Addendum Write Up

Addendum: 02

Project: 14049 Dexter Township, Michigan New Fire Sub-Station No 2

Addendum Reason: Response to Bidders questions.

WATCH ROOM O.H. DOOR CONTROL PANEL

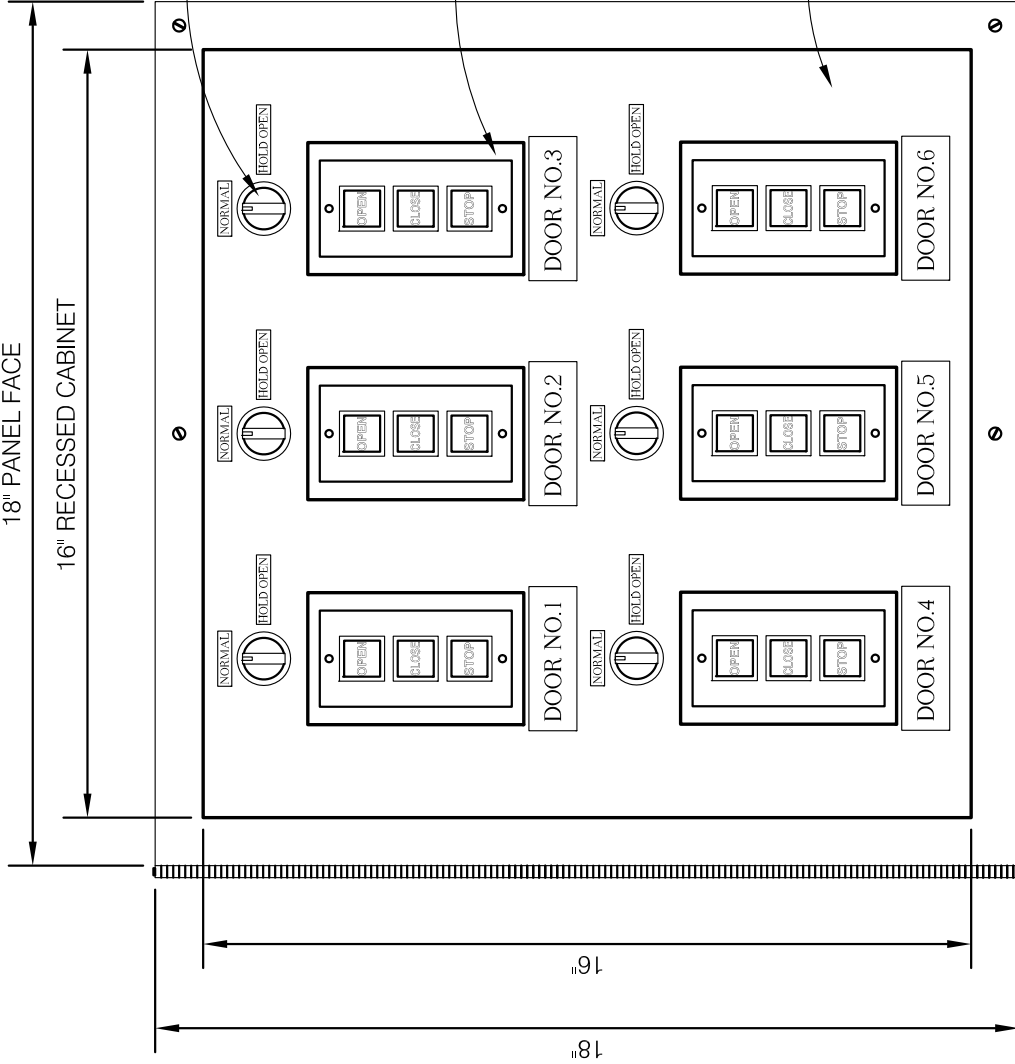
Item	Description
1	Refer to Section 01 00 00 – General Requirements. Payment of Prevailing Wages is not a requirement for this project.
2	Refer to Section 08 36 13, para 2.3.D.4 – Sectional Overhead Doors – See attached Sketch No. SK-1 for custom control panel detail that was missing from Electrical Drawing Sheet E-211.
3	Refer to Section 08 36 13, para 2.3.E – Sectional Overhead Doors – Manufacturer's own monitored safety photo eyes may be used in lieu of system specified.
4	Refer to Section 10 99 90 – Miscellaneous Specialties – Add the following paragraph 2.10: 2.10 FLAGPOLE A. Furnish and install one (1) flagpole in the location shown on Drawings. Flagpole shall be manufactured by Concord Industries, Inc., American Flagpole Equipment Company, Poletech Co., Inc. or approved equal. Flagpole shall be ground set, continuous or cone tapered seamless aluminum flagpole 35' high above the ground, having minimum diameters of 6" at butt, 3-1/2" at top, and minimum wall thickness of .188". Provide a 6" diameter aluminum ball at top, revolving aluminum truck with double sheaves, two aluminum cleats, two (2) sets of 5/16"

2-POSITION GREEN ILLUMINATED SELECTOR SWITCH - EQUAL TO SCHNEIDER ELECTRIC MODEL #ZB4BK1233 (ILLUMINATED IN HOLD OPEN POSITION) (TYPICAL FOR 6)

FLUSH MOUNTED 'OPEN-CLOSE-STOP' DOOR OPERATOR SWITCH (TYPICAL FOR 6)

5" DEEP, SHOP PRIME PAINTED, FLUSH MOUNTED STEEL CABINET WITH PIANO HINGED 304 STAINLESS STEEL PANEL FACE

SCALE: 3" = 1'-0" PROVIDE BLACK LAMINATED PHENOLIC PLASTIC SWITCH TAGS w/ WHITE LETTERING (TYPICAL)
